RE: Mid- and Long-Duration Energy Storage Strategy Study

Please accept these comments on the Mid- and Long-Duration Energy Storage Strategy Study.

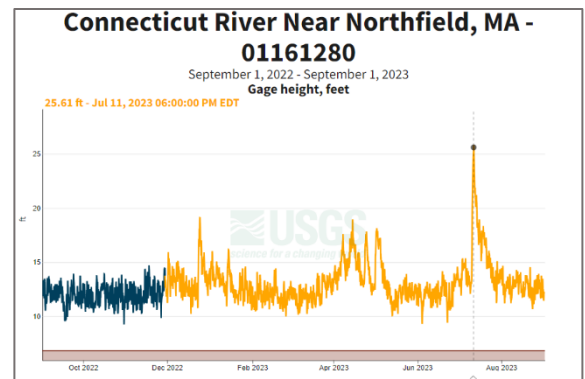
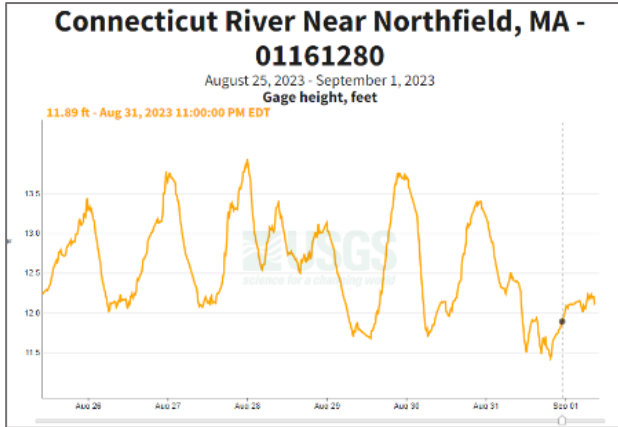
The graph to the right gives some sense of the fluctuations in water level over the last year, although this is about 9 river miles upriver from the Northfield intake / outflow, and not all the fluctuations shown here are caused by Northfield. The water level is shown varying from about 9 feet to about 26 feet. The highest levels, on July 11, correspond to this

summer’s floods. The daily fluctuations, however, are caused by “hydropeaking” — river flows that vary depending on hydropower production. The hydropeaking shown in this graph comes both from Northfield and several upriver projects, particularly Vernon Dam, the dam directly upstream on the Connecticut River.

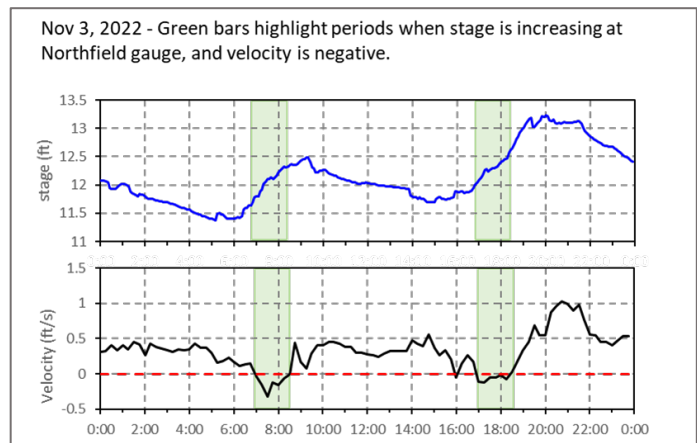
A zoomed-in look at a relatively average few days, such as the last week (Aug 25-Sept 1, 2023, captured Sept 1 at about 9:30 AM), gives you some sense of more regular fluctuations. Here the river is going up and down over the course of a few days from 11.5 to 14 feet, so 2.5 vertical feet of variation. At the Northfield intake / outflow location downstream, this would be more extreme, likely closer to 5-6 feet in variance.

One situation when you can directly see the effect of Northfield, even at the USGS gage 9 miles upriver, is when the velocity actually goes negative at the same time the river level (“stage”) goes up. Hydropeaking from the upstream Vernon Dam would cause stage *and* velocity to increase, so this increased stage with *negative* velocity is the effect of Northfield overpowering whatever flow is coming out from Vernon. High generation from Northfield has made the river flow backwards for miles, all the way up to the USGS gage.
